CITY OF ALBUQUERQUE

Site: Rohan Subdivision

Re: Drainage Ordinance (14-5-2-1) Violations for Erosion and Sediment Control

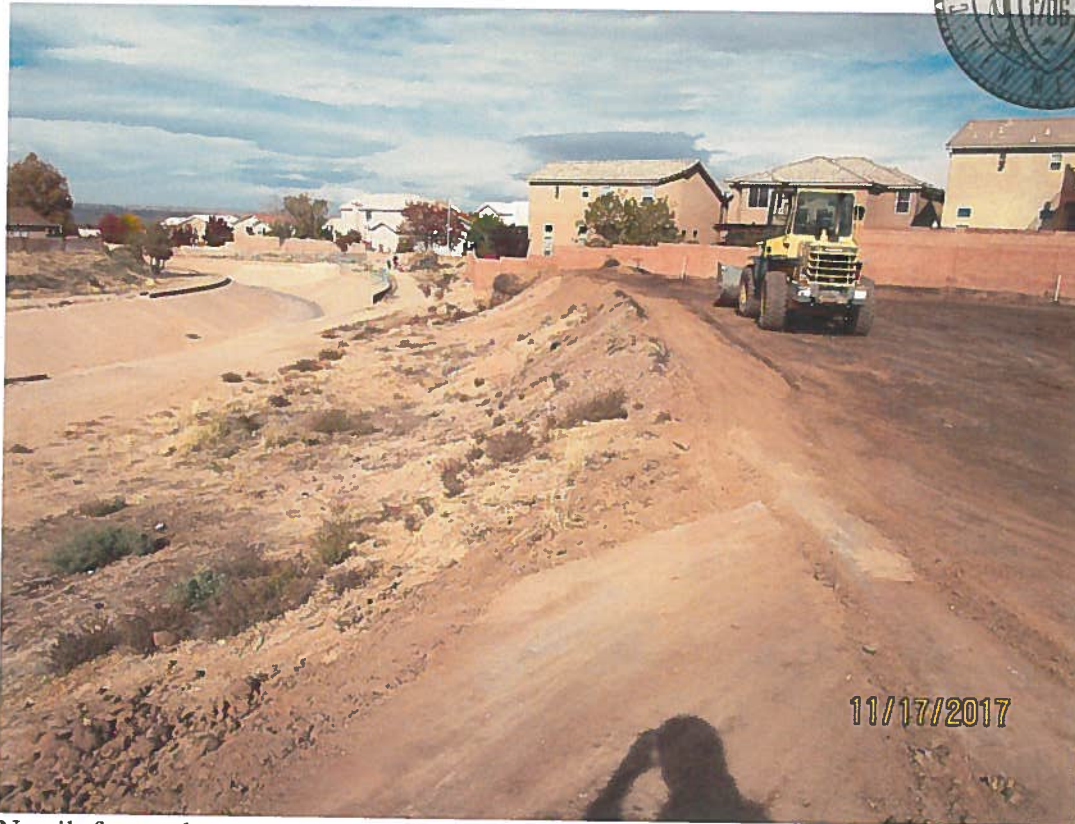
1. Earth disturbance has begun without installation of any sediment BMPS.

No stabilized Construction Entrance to site and no silt fence along street.

1. Install BMPS per the approved Erosion and Sediment Control Plan.
